**Preservation Department – Item 3, LPC-25-05585**

**83 Horatio Street – Greenwich Village Historic District**  
**Borough of Manhattan**

NEW YORK CITY LANDMARKS PRESERVATION COMMISSION  
REVISED 10/30/25

83 HORATIO STREET  
NEW YORK, NY, 10014

1 10/30/25 PROPOSED REAR SITE ELEVATION  
1/8" = 1'-0"

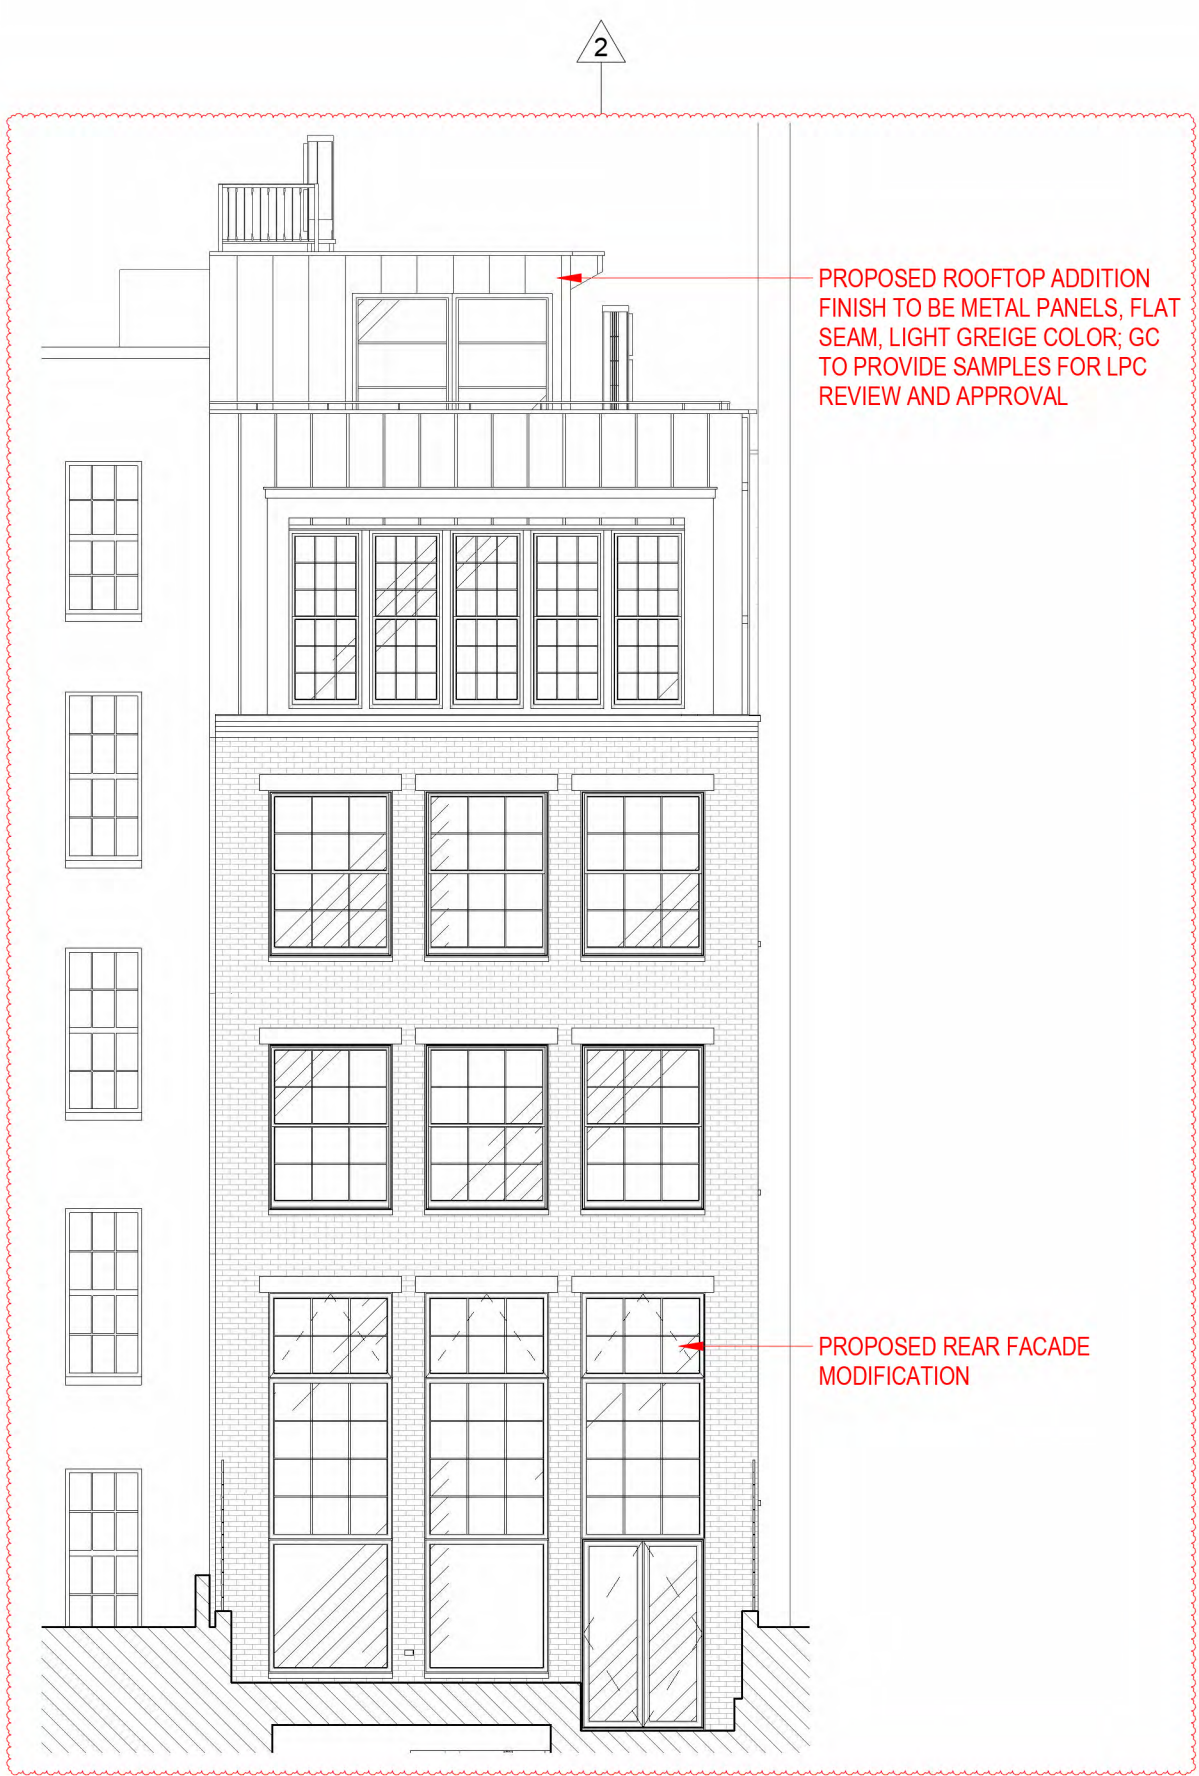
- EXCAVATIONS AT CELLAR LEVEL;  
(rev103025: SHALLOWER EXCAVATIONS AT REAR; NO NEW EXCAVATIONS AT EXISTING CELLAR FOOTPRINT EXCEPT AT ELEVATOR SHAFT)
- NEW REAR YARD DESIGNS;
- A NEW DOUBLE-HEIGHT OPENING AT THE REAR FACADE AT GARDEN (BASEMENT) LEVEL;  
(rev103025: SIMPLIFIED REAR FACADE, PRESERVE BRICK PIERS)
- A NEW ELEVATOR ON THE INTERIOR (ELEVATOR OVERRUN AT ROOF LEVEL, NOT VISIBLE TO STREET OR FROM HIGHLINE)
- MODIFY AND ENLARGE EXISTING STAIR BULKHEAD (LIMITED VISIBILITY FROM GANSEVOORT SQUARE ONLY)  
(rev103025: DECREASED SIZE; MOVE HVAC UNITS; DELETE UPPER ROOF ACCESS AND RAILING)

10/30/25 PROPOSED REAR FACADE - VIEW FROM WEST

10/30/25 PROPOSED REAR FACADE

1 5/6/25 PUBLIC HEARING BUILDING SECTION  
1/16" = 1'-0" PREVIOUSLY PROPOSED DESIGN 05/06/25

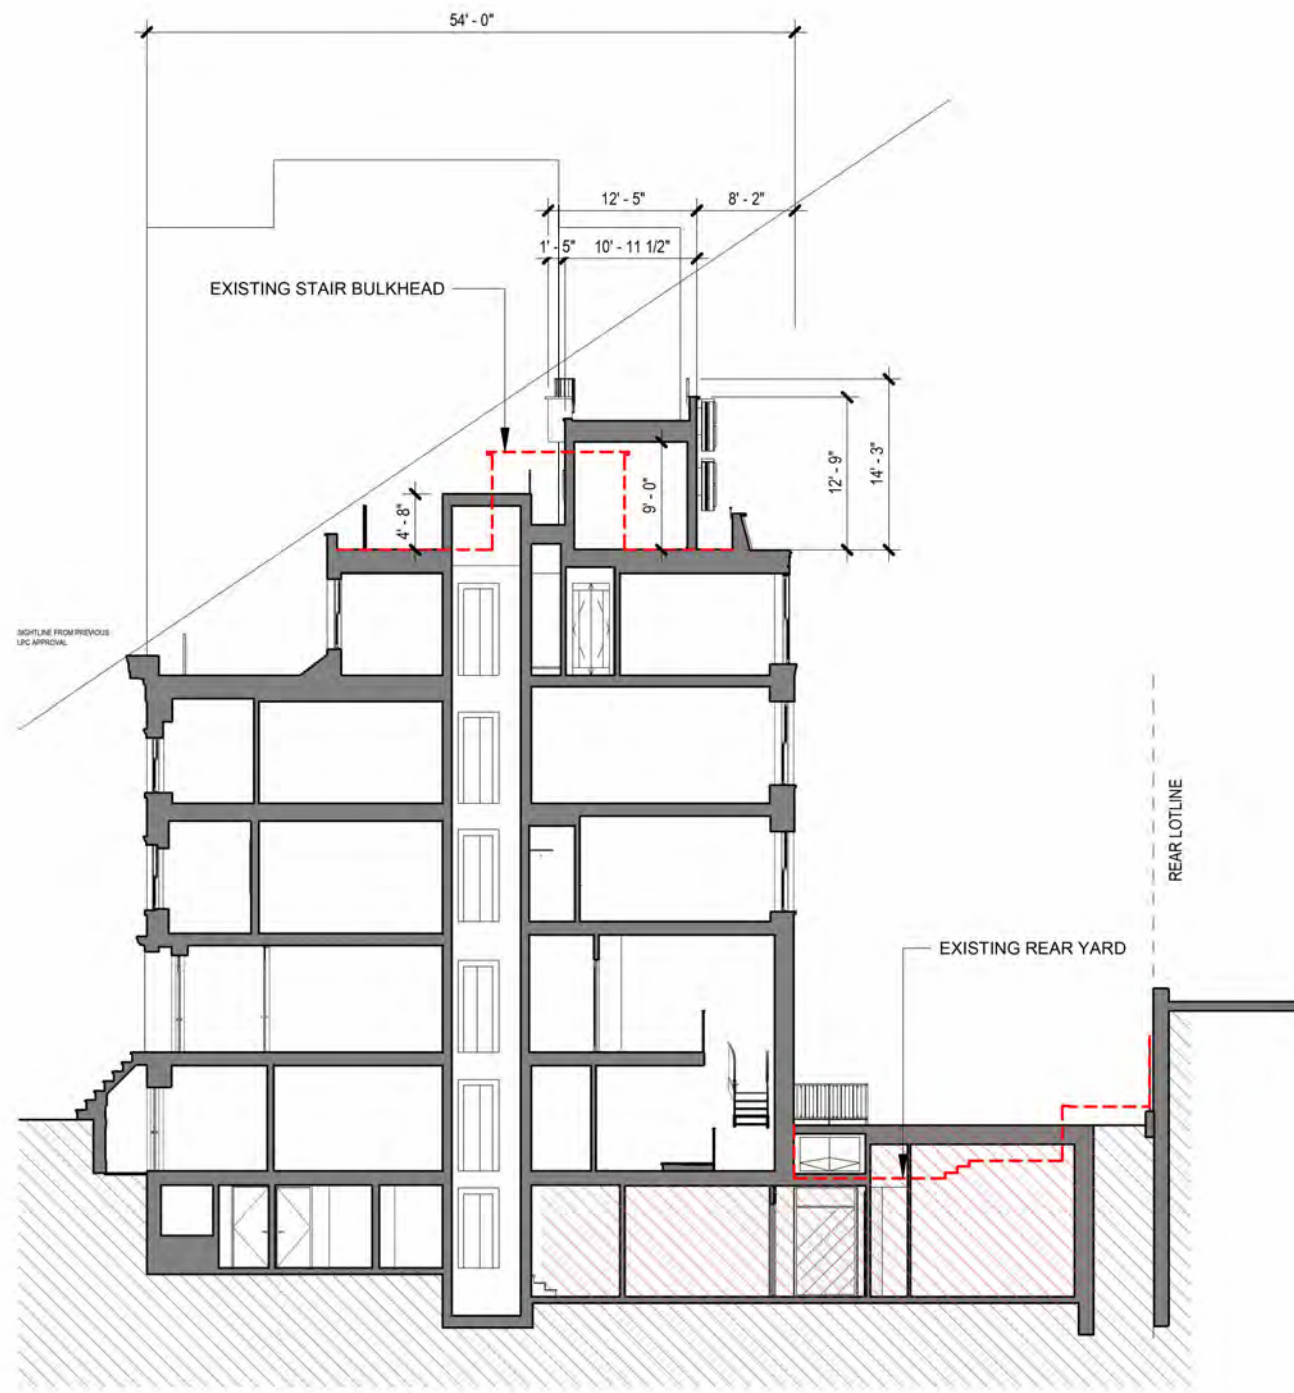
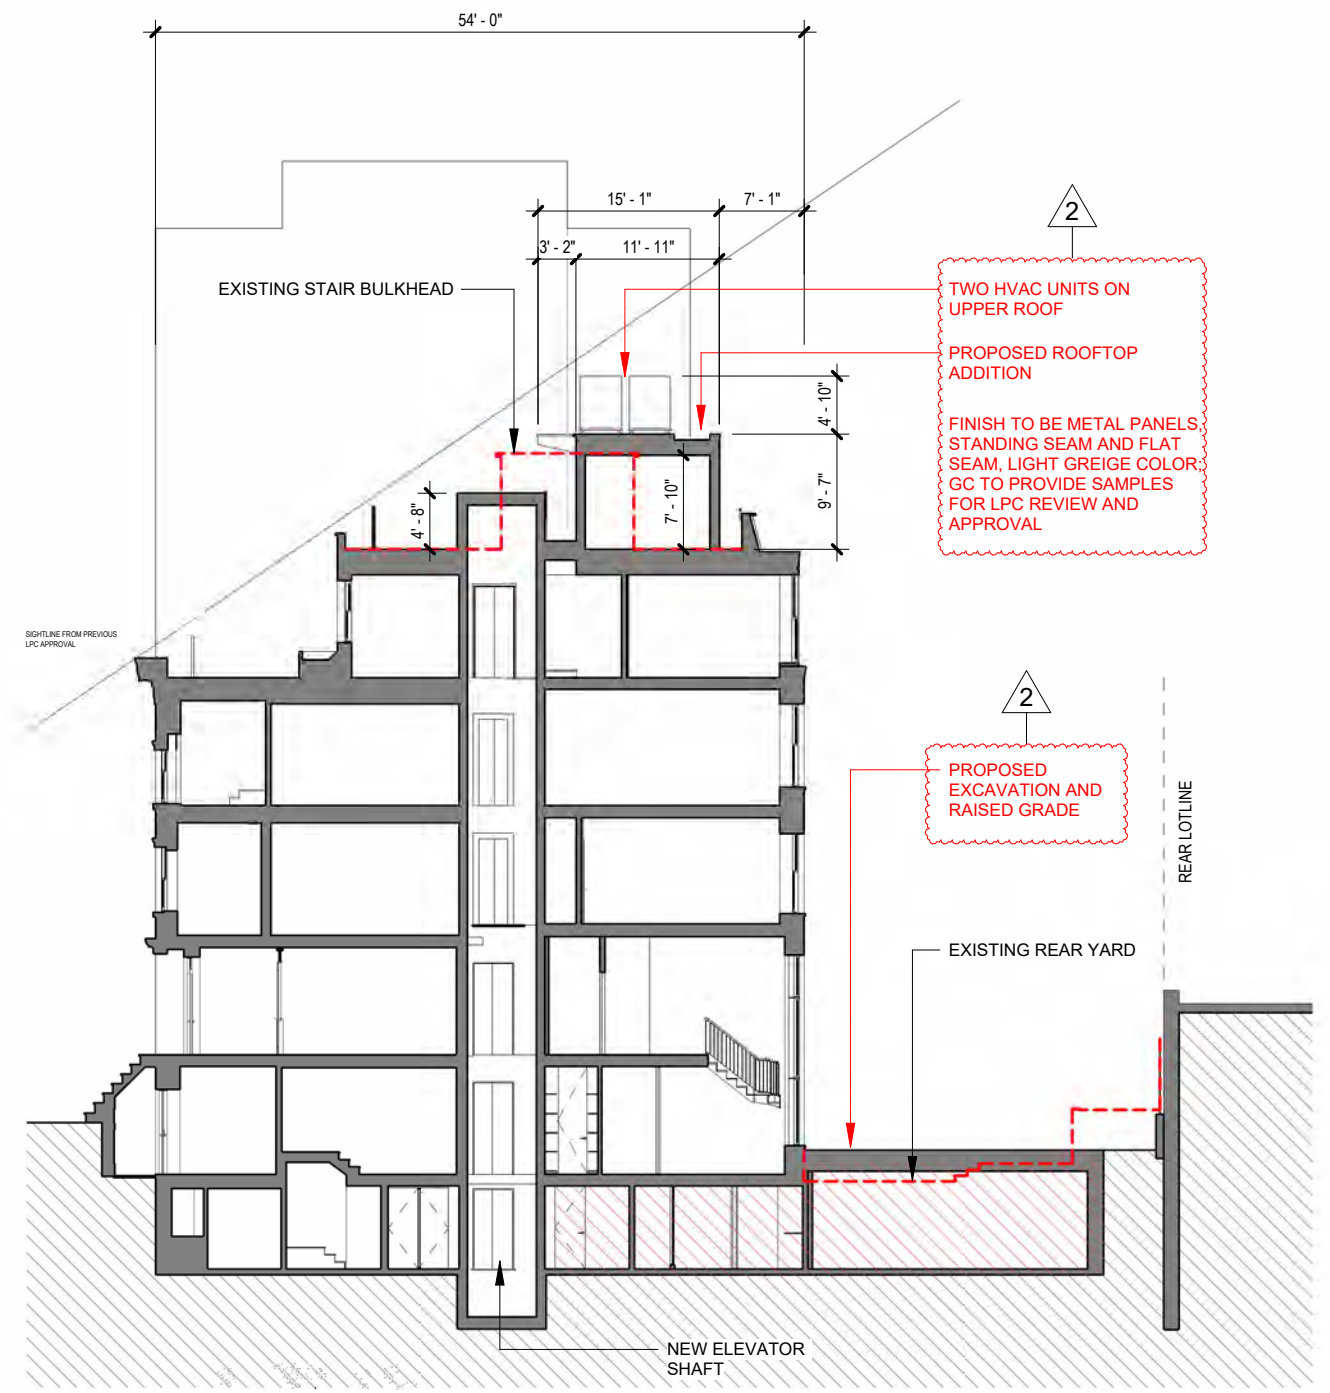
NOTE: EXISTING CELLAR IS SHOWN 2 1/2" LOWER THAN ACTUAL IN 5/6 PRESENTATION DUE TO SURVEY ERROR. CORRECTED SIZE SHOWN IN 10/30 PROPOSAL.

2 10/30/25 PROPOSED BUILDING SECTION  
1/16" = 1'-0" PROPOSED DESIGN

4 10/30/25 PROPOSED REAR YARD SECTION LOOKING WEST  
1/8" = 1'-0"

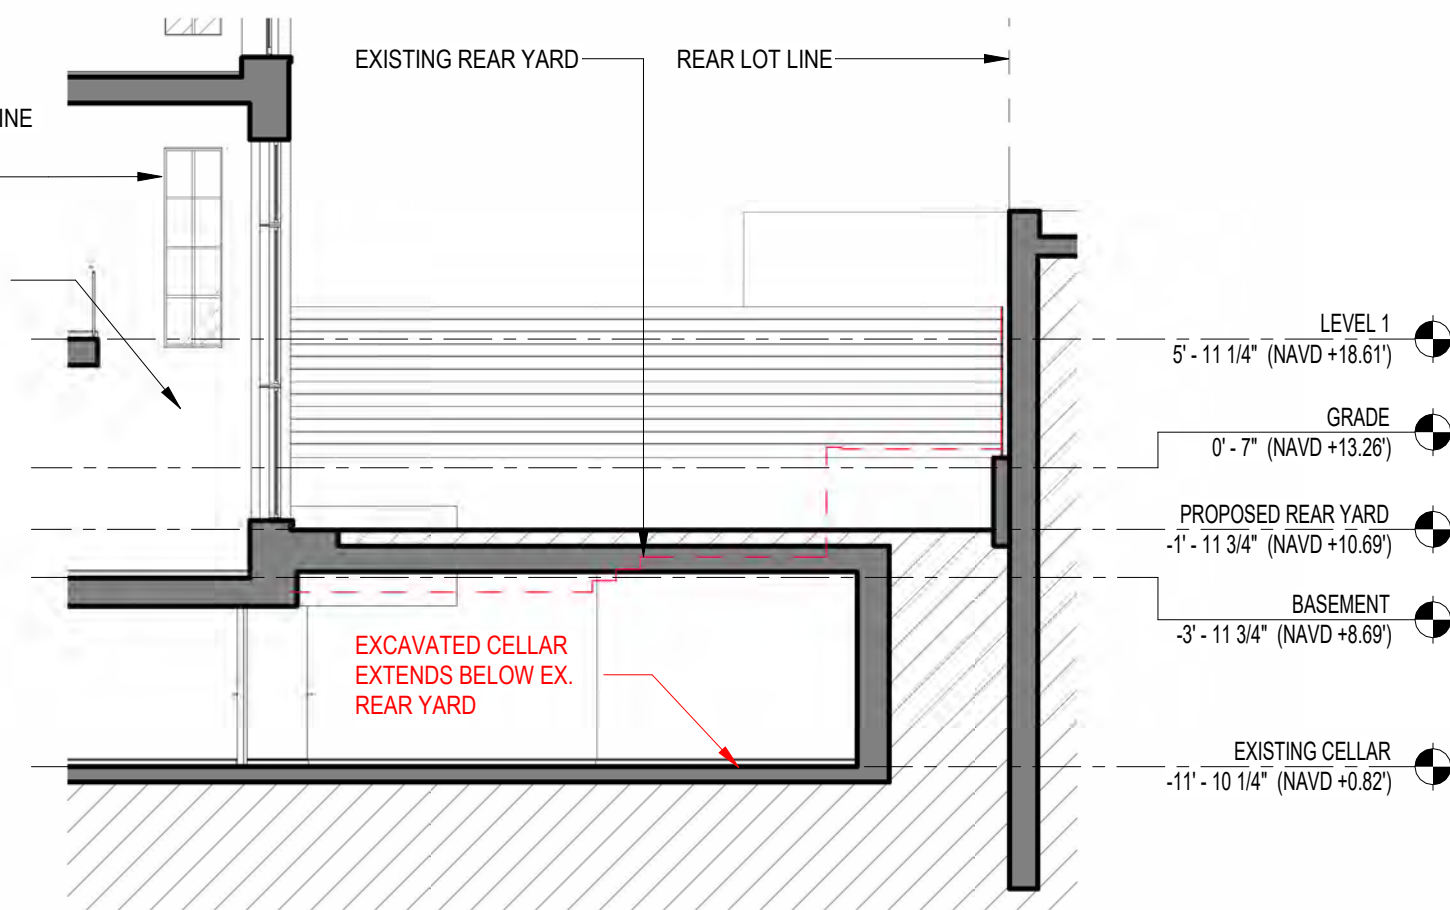
— EXISTING RETAINING WALL  
BELOW TO REMAIN

## — STRUCTURAL SKYLIGHTS

— PORCELAIN PAVERS

— NEW WOOD FENCE ON THREE SIDES

PROPOSED NEW LOTLINE  
WINDOW (ENLARGE  
EXISTING OPENING) \_\_\_\_\_

NEW DOUBLE HEIGHT  
OPENING FROM  
BASEMENT LEVEL

3 10/30/25 PROPOSED REAR AXON VIEW - WEST

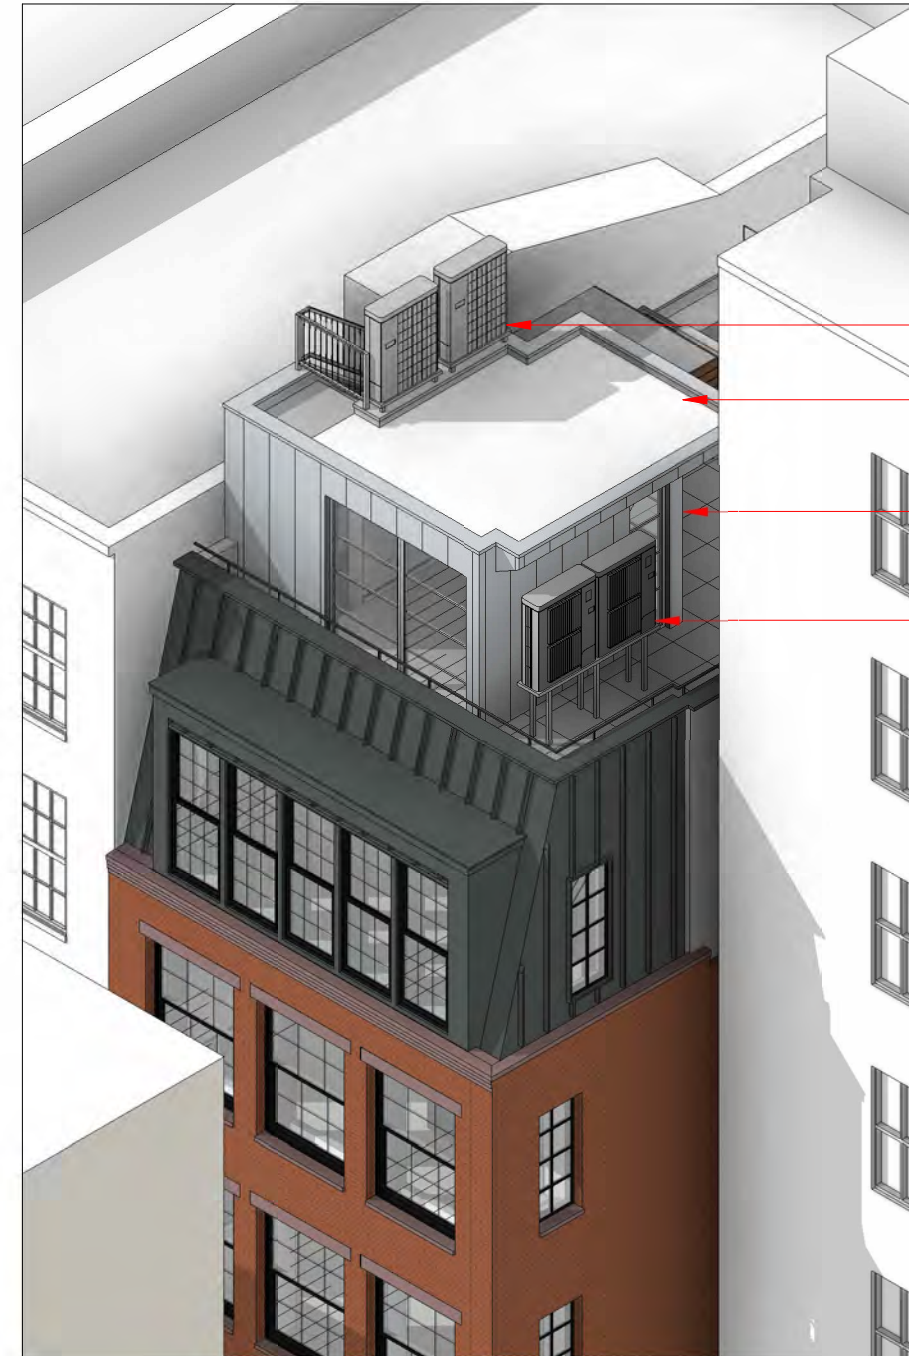
- 2
- TWO HVAC UNITS AT UPPER ROOF LEVEL
  - NO ACCESS TO UPPER ROOF; NO RAIL
  - FLAT SEAM METAL PANELS, LIGHT GREIGE COLOR; GC TO PROVIDE SAMPLES FOR LPC REVIEW AND APPROVAL
  - TWO HVAC UNITS AT MAIN ROOF LEVEL IN SIDE AREA WAY

3 10/30/25 PROPOSED FRONT PERSPECTIVE - SOUTH

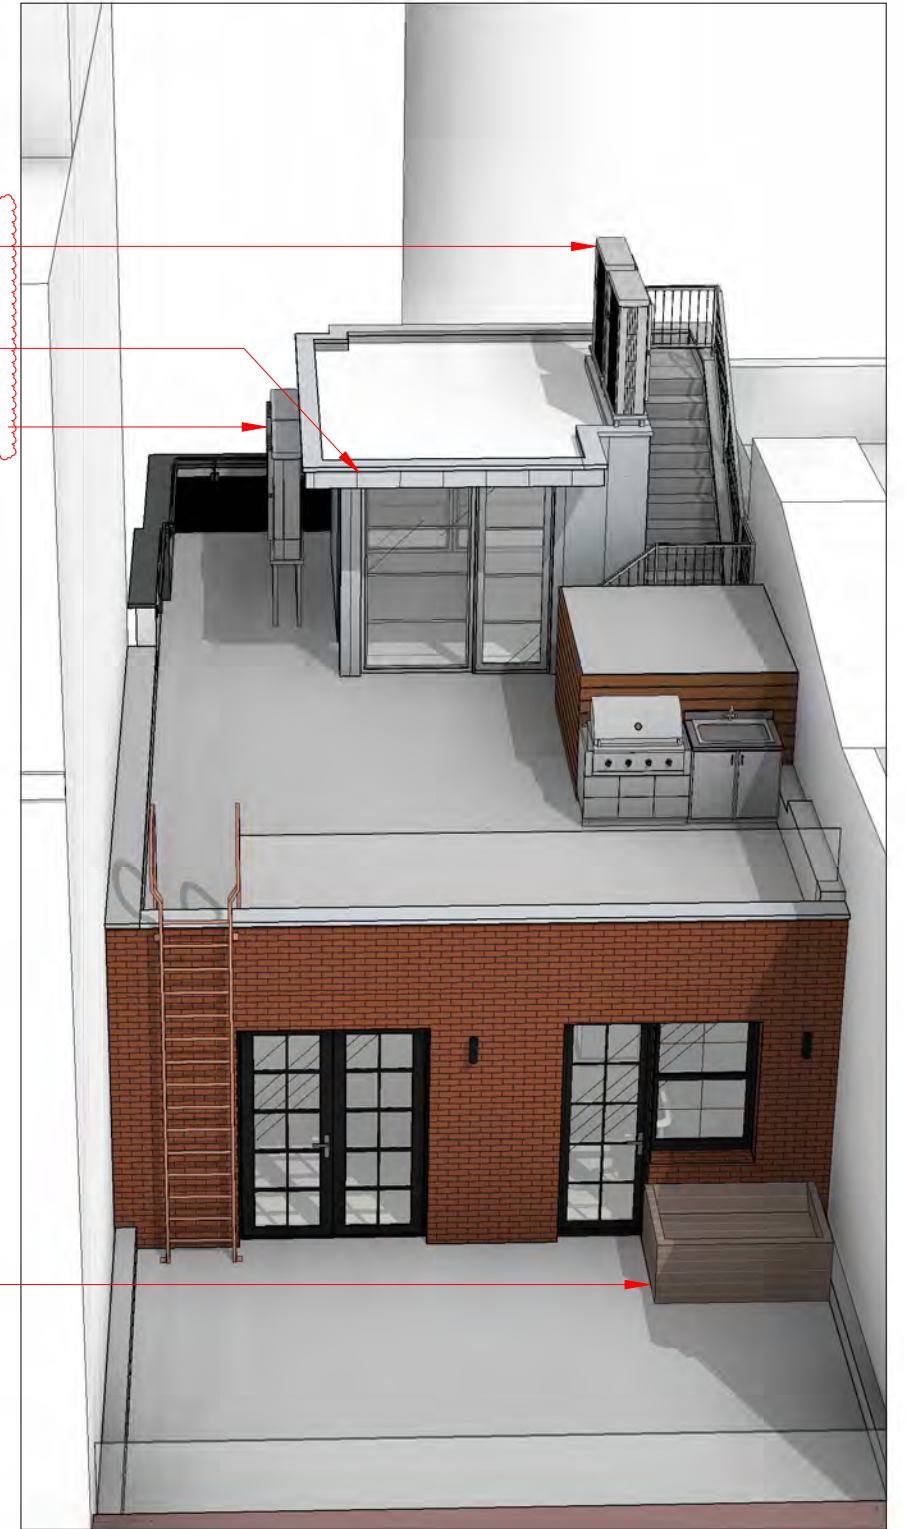
2  
TWO HVAC UNITS AT  
UPPER ROOF LEVEL  
FLAT SEAM METAL PANELS,  
LIGHT GREIGE COLOR; GC  
TO PROVIDE SAMPLES FOR  
LPC REVIEW AND APPROVAL  
TWO HVAC UNITS AT MAIN  
ROOF LEVEL IN SIDE AREA WAY

2  
(NO CHANGE TO  
EXISTING PLANTER BOX;  
NO NEW SKYLIGHT)
